Sent: 13/11/2019 9:09:34 AM
Subject: 11 Moore Street, Clontarf - DA 2019/1149
Attachments: Letter Council 1.pdf;

Re: 11 Moore Street, Clontarf – DA 2019/1149

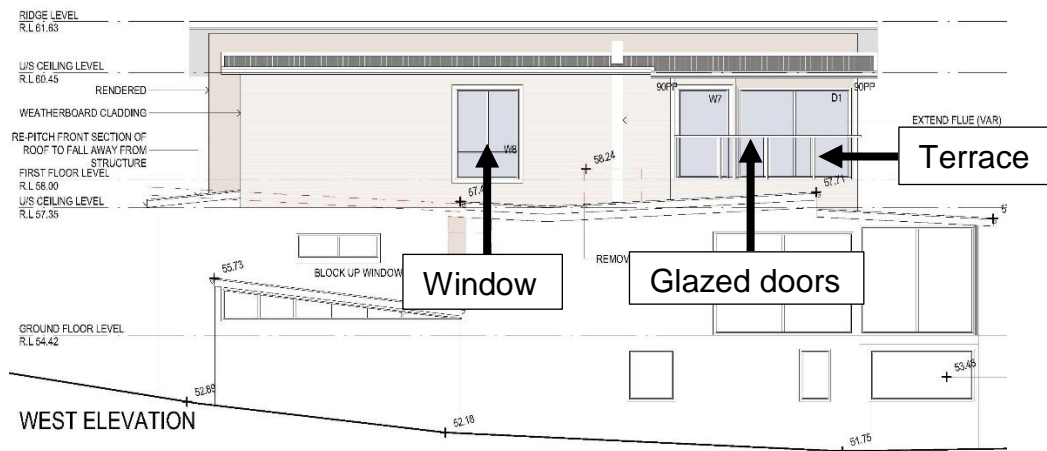
Comment: The building layout does not provide for privacy between the occupants of the neighbouring dwellings. The elements of the proposal that result in overlooking are the large areas of glazing on the western façade of the proposed upper level and the proposed upper terrace.

These elements are not designed to maximise privacy, but are designed to maximise views from the subject dwelling house. However, they provide direct views into the principal private open space and master bedroom of the neighbouring property owned by Mr Kremer.

Comment: The proposed additions do not orient the west facing glazing and upper level terrace to limit overlooking. Instead they are oriented towards the neighbouring property, as shown in the following photographs:

Comment: The proposed windows, doors and terrace are separated by 5.5m from the principal private open space of 13 Moore street and 7.0m from the master bedroom window of 13 Moore Street. The separation distance is not sufficient to mitigate overlooking impacts.

The impact may be mitigated through the installation of a 1.6m high privacy screen along the entire western side of the proposed upper level terrace and obscure glazing to a height of 1.6m above floor level for the window that is proposed within the centre of the upper level western façade.

1. *A privacy screen is to be provided along the entire western side of the proposed upper level terrace. Such screen is to:*
 - *Be a minimum of 1.6m in height; and*
 - *Have no individual opening more than 30mm wide; and*
 - *Have a total area of all openings that is no more than 30% of the surface area of the screen or barrier.*

2. *The upper level window on the western façade of the building located nearest to the northern end of that façade is to be provided with frosted glazing to a minimum height of 1.6m above the finished floor level of the building.*
